Woodlawn Wind Farm

Key Consultation Correspondence

Woodlawn Wind Farm – Sally Trig Station

Annex A

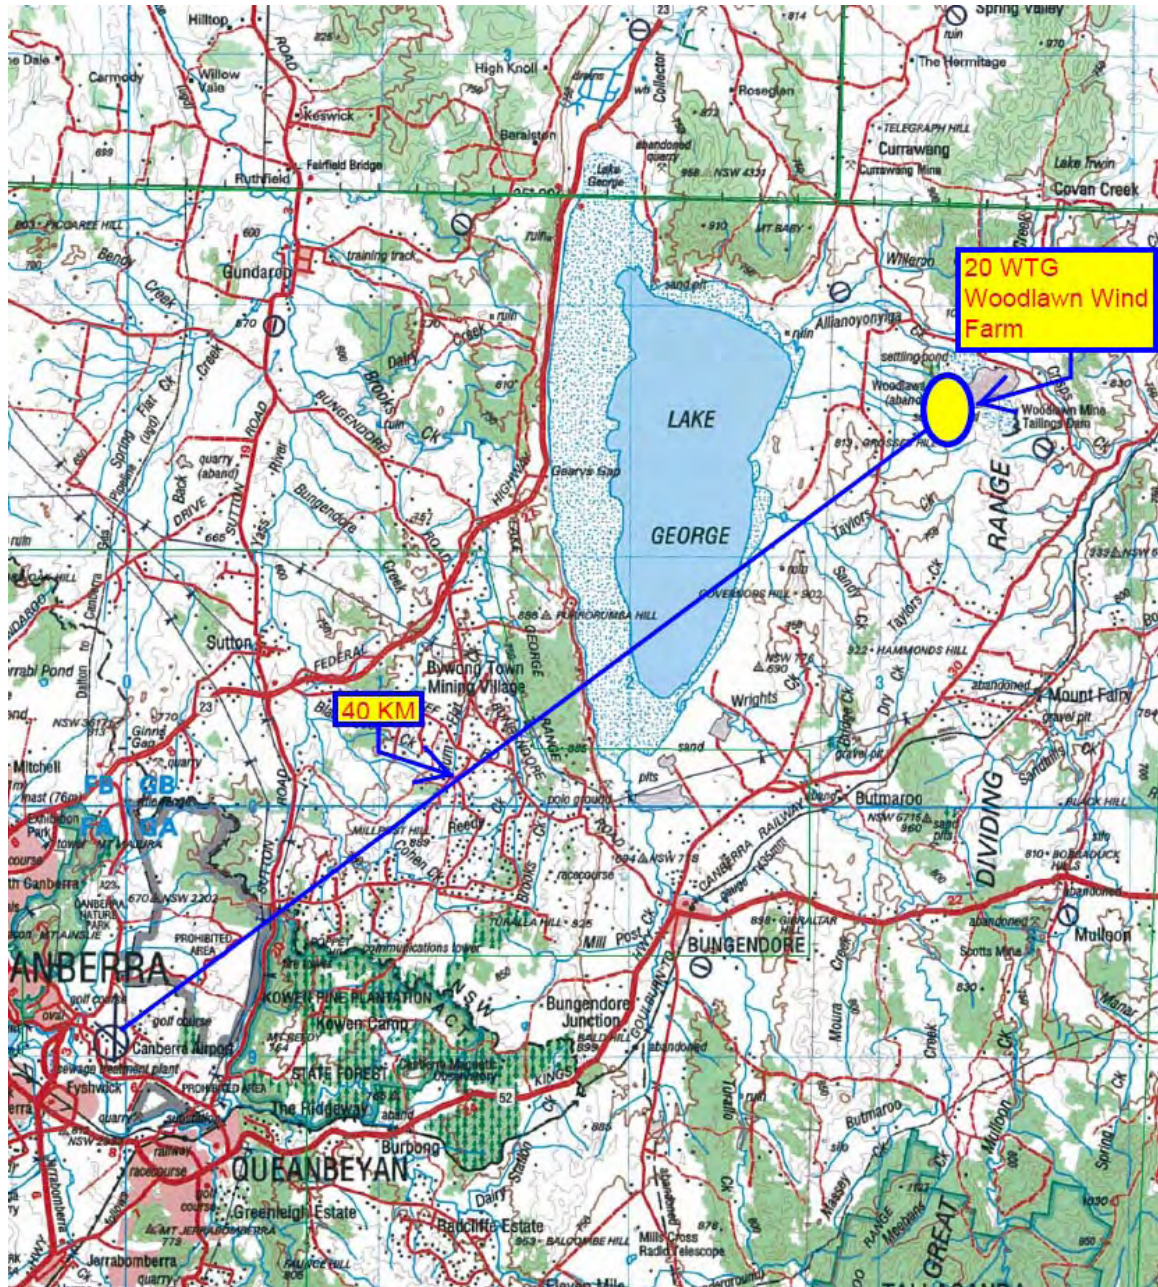
A map identifying the location of the proposed turbines in relation to Canberra Airport is attached at Annex A. Canberra Airport is approximately 40 km SW from the closest turbine. Goulburn aerodrome is approximately 30 km north of the closest turbine.

Could you please review this information and confirm or otherwise your concurrence that the proposed Woodlawn wind farm will not represent a hazard to air navigation.

On 6 November 2008 you wrote seeking CASA confirmation that the windfarm is not a hazard to air navigation. CASA cannot give that confirmation.

While the windfarm is distant from Goulburn and Canberra Airports, that does not preclude the windfarm posing a hazard to aircraft operations on other airstrips that might be in the vicinity of the development. Such airstrips would be unknown to CASA as there is no regulatory requirement for them to be notified to us or to be shown on aeronautical charts.

You should also note that the minimum flight height above ground is 500 feet (152.4m) except when landing taking off or due to stress of weather. Since the windfarm tower will be up to 125m there is little margin for error.

FIGURE 3.3: Amended Woodlawn wind farm layout

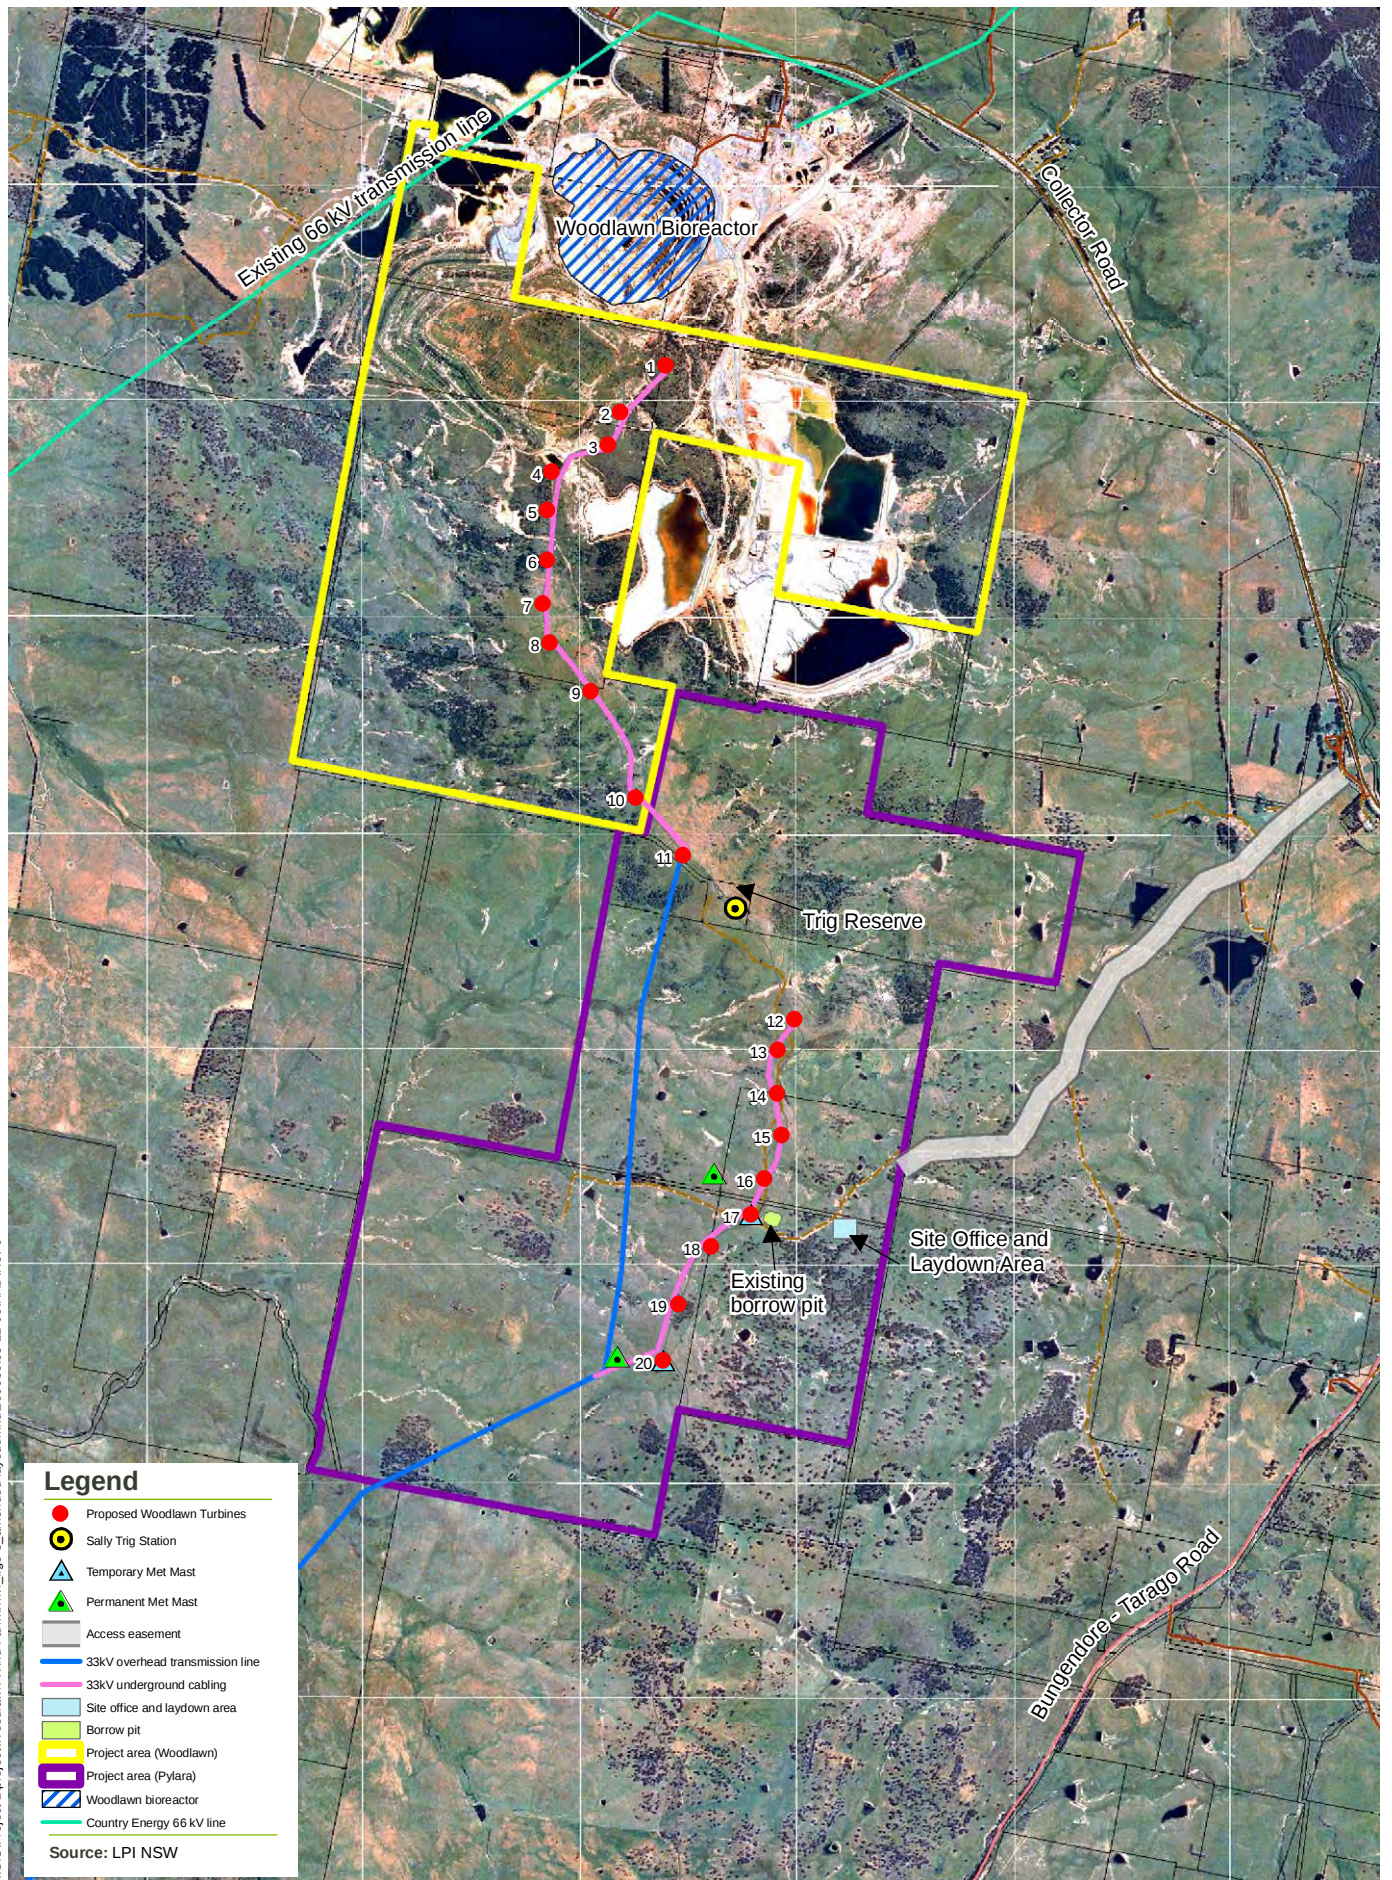
Sally Trig Station and its associated Trig Reserve are located on the highest part of the ridge and between Turbines 11 and 12. The potential impact of the amended wind farm development on the survey activities at Sally Trig Station is being reviewed as part of current planning studies. It is noted that Sally Trig Reserve constitutes Crown Land and any activities within the Trig Reserve would require a lease or licence from the Department.

Based on the above information and in particular for the locations of Turbines 11 and 12 either side of the Trig Station, please provide advice on the site significance for survey operations and any issues arising from the revised turbine siting in relation to Sally Trig Station.

Though the Woodlawn windfarm structures will interfere to some extent with the utility of our Trigonometrical Station Sally, the Land and Property Management Authority **has no objections to the proposed position of the structures** as shown on the attached diagram.
